# Planning Application - DCC/4336/2023

## Shared use trail – Cranbrook to Exeter

### Summary for Devon Countryside Access Forum

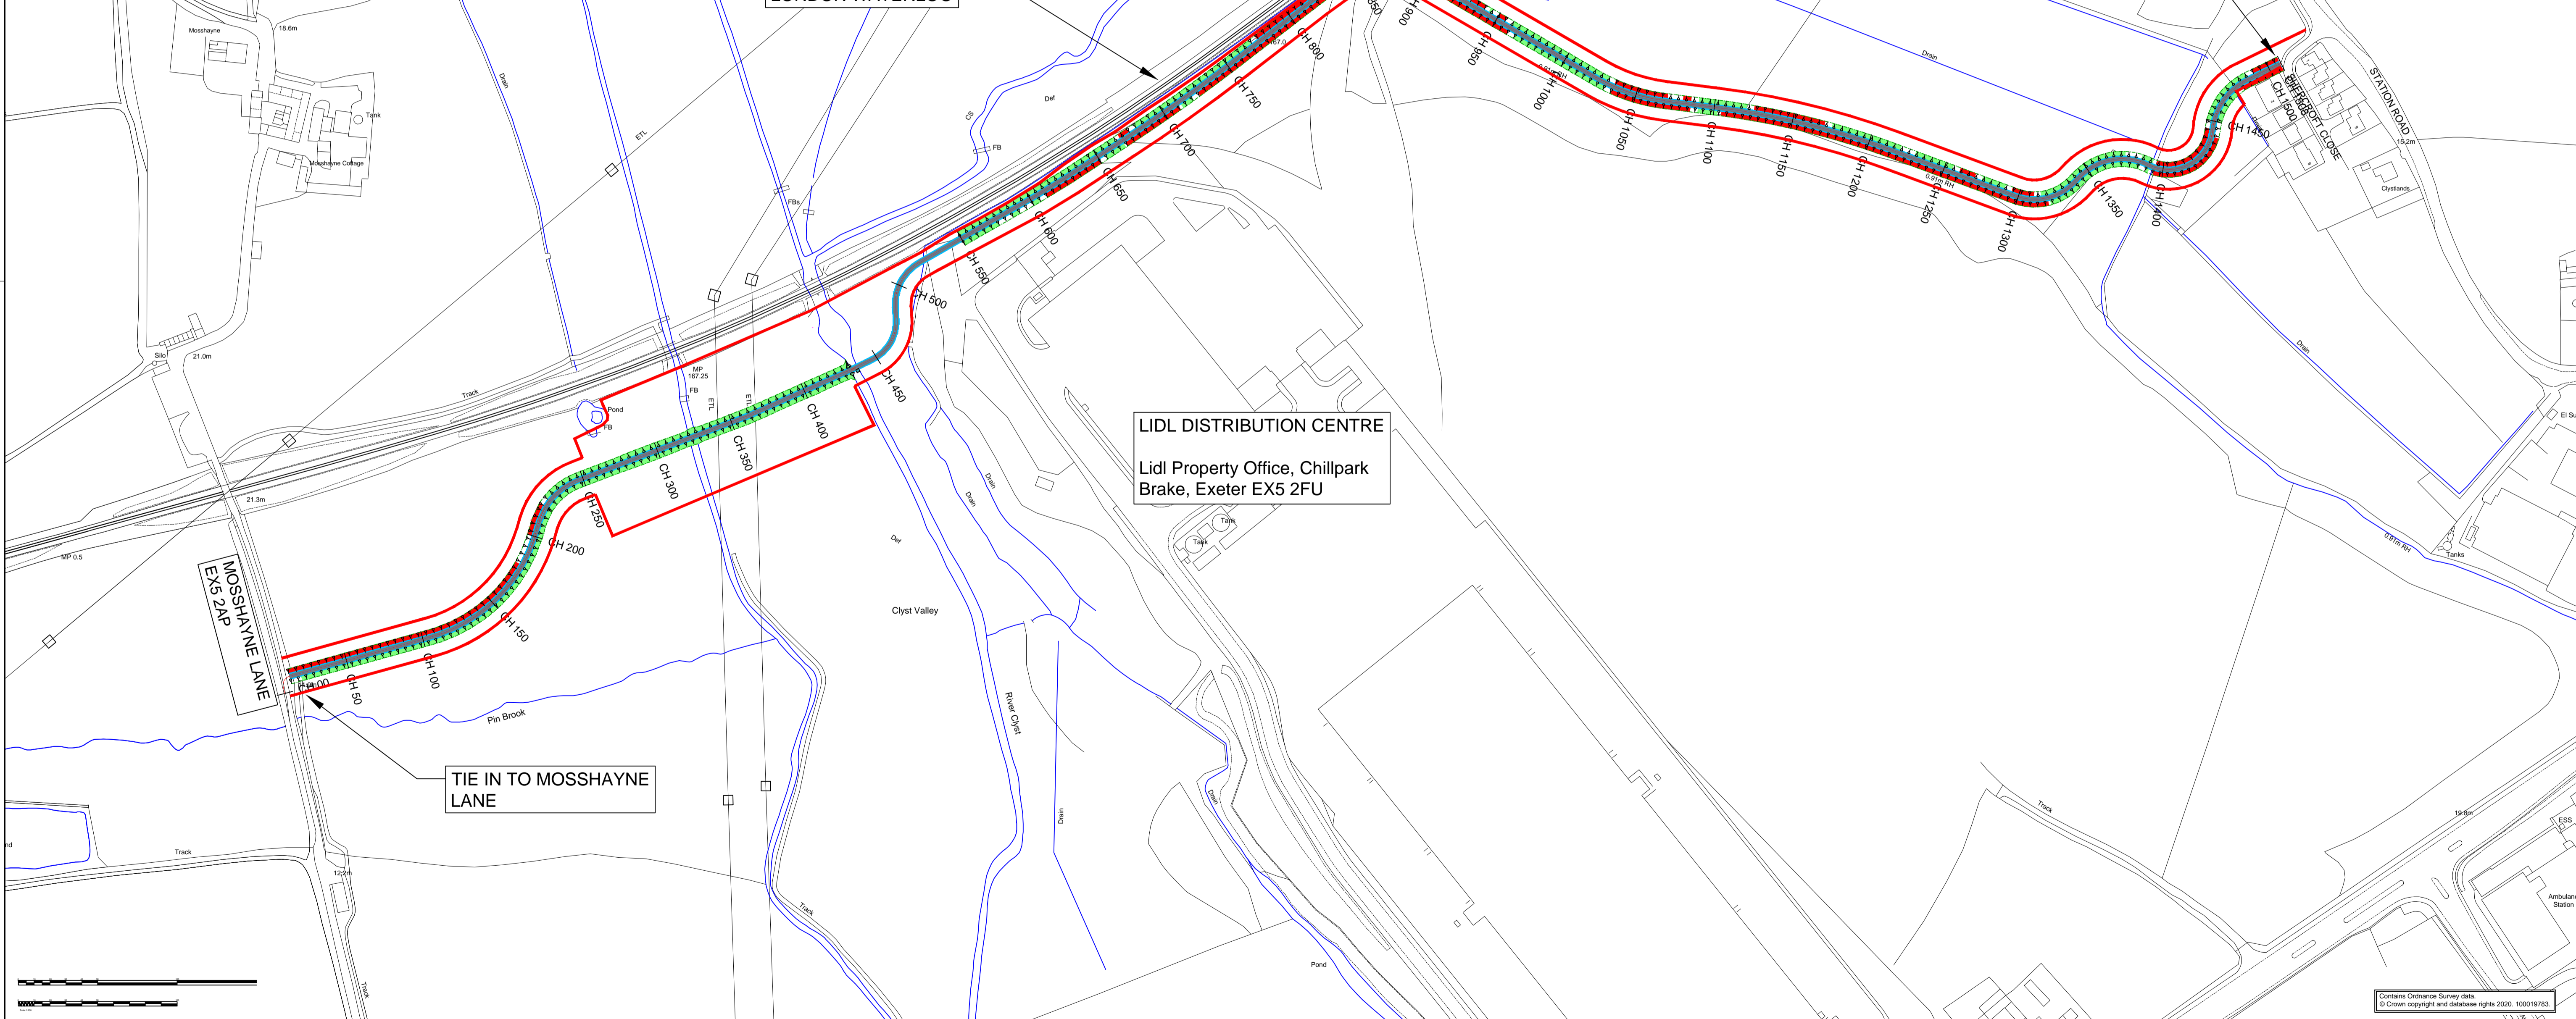
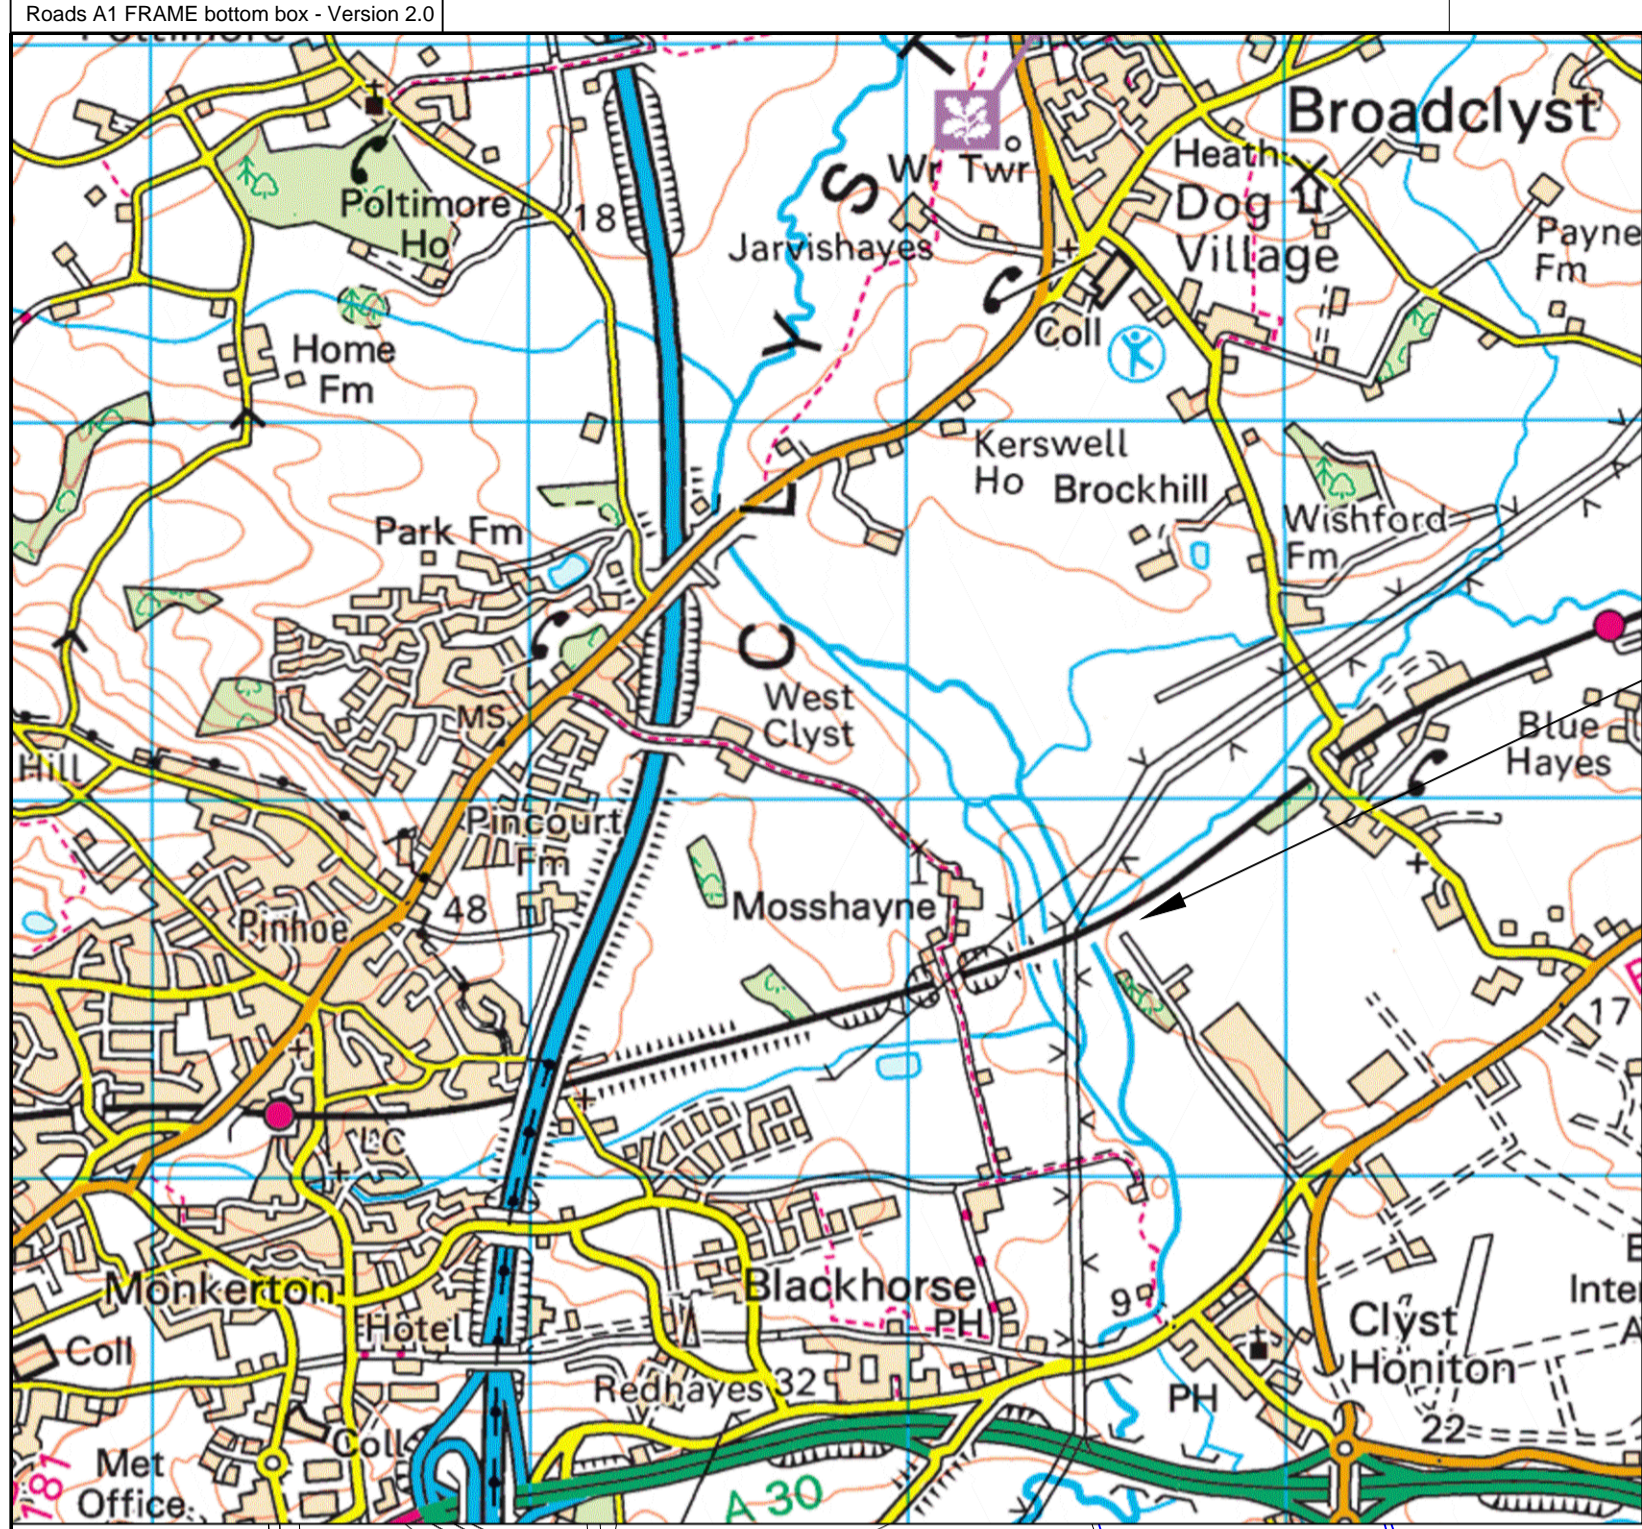
At the eastern end the trail goes through the Broadclyst SANGS site on which there was an earlier consultation. The SANGS site is not mentioned in the planning application nor marked on the location maps.

There are no public rights of way to the north, south or east of the trail for some distance. The trail does not connect directly to Cranbrook within the current application. It comes out on Station Road in Broadclyst, a relatively busy road. See the second map. Whilst the proposed trail lies outside of the Emerging Cranbrook Plan area, it will connect with the Bluehayes expansion area, to the west of Cranbrook. It is understood that the Bluehayes applicant is already in discussion with East Devon District Council regarding the development. It will be important to consider how the proposed trail will link in to the Bluehayes Expansion area and beyond. The proposed link can aid in the delivery of

Clyst Valley Trail proposal map - northern section

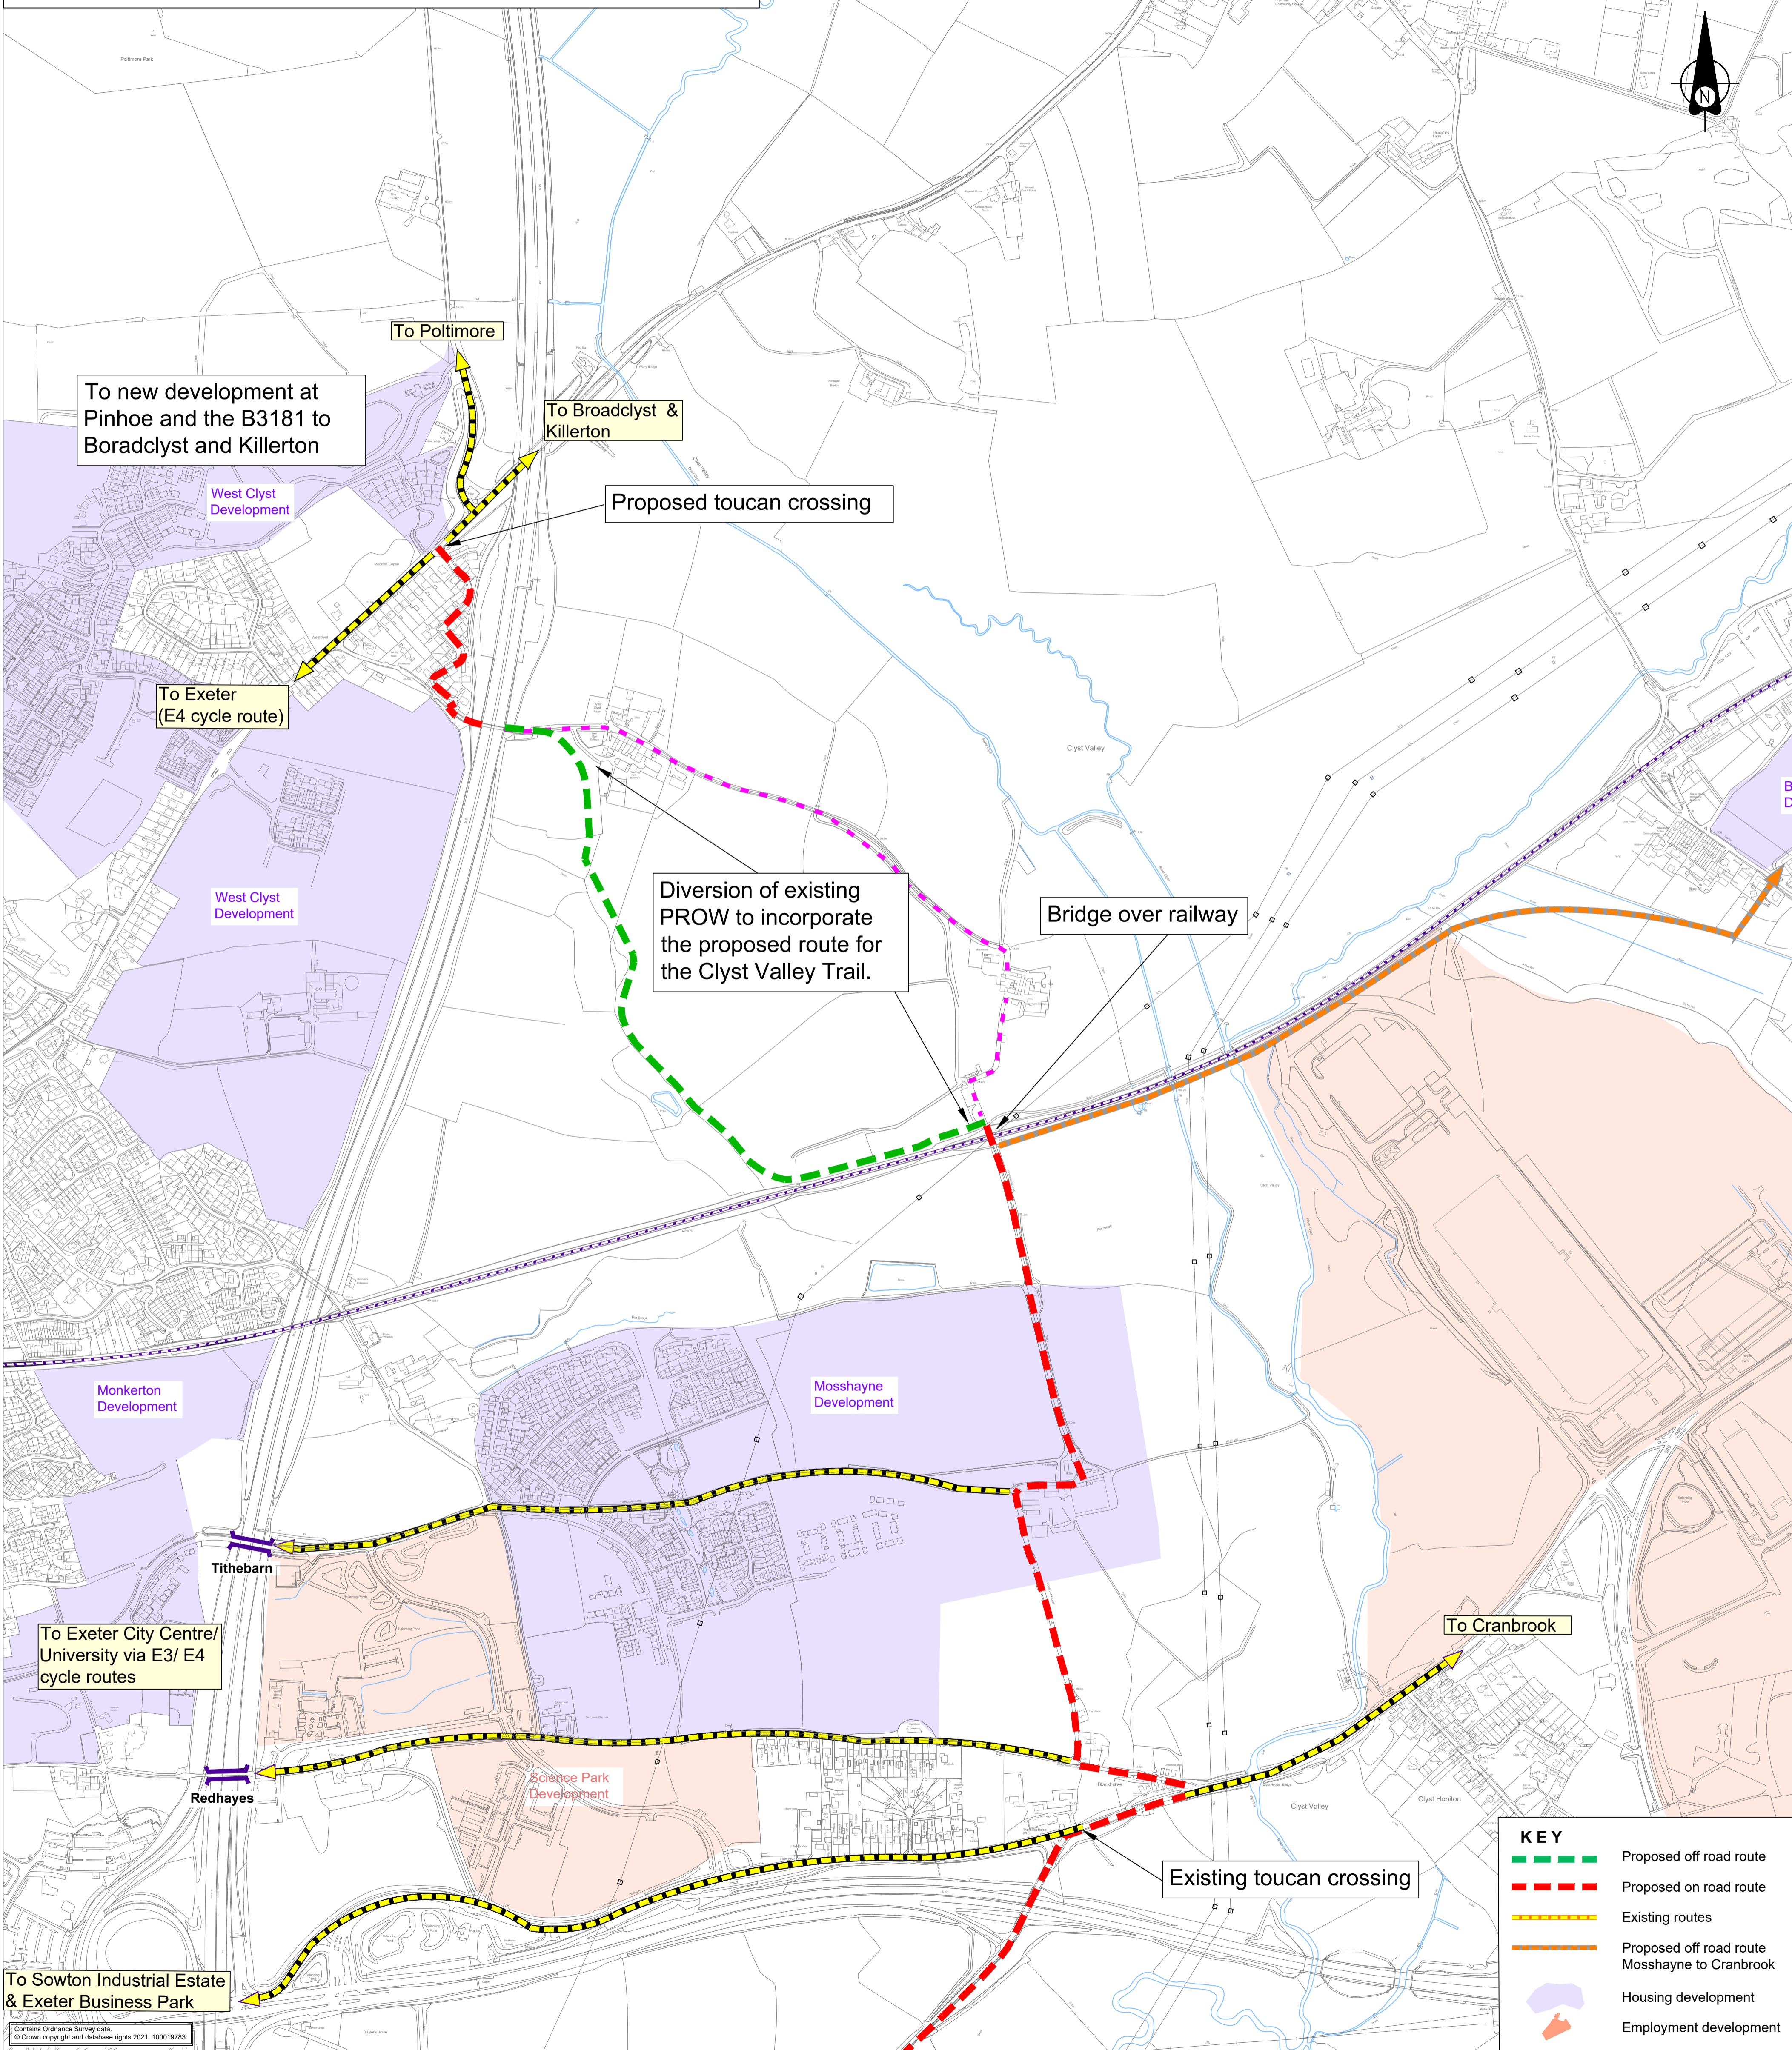
The application contains no information as to how cyclists proceed from the end of the trail, given that Mosshayne Lane is currently a private road. See the third map. However, the Mosshayne Lane development (14/2761/MOUT) was approved with conditions by East Devon District Council in 2016 and the applicant is the landowner. This planning application clearly shows Mosshayne Lane as a cycle route heading north to Killerton. The legal processes for permitting cycle use will presumably be finalised once the development or the trail proceed. The fourth map shows the trail in relation to the much longer Clyst Valley trail proposal, both within the Clyst Valley Regional Park. This map was part of the consultation on the Clyst Valley trail.
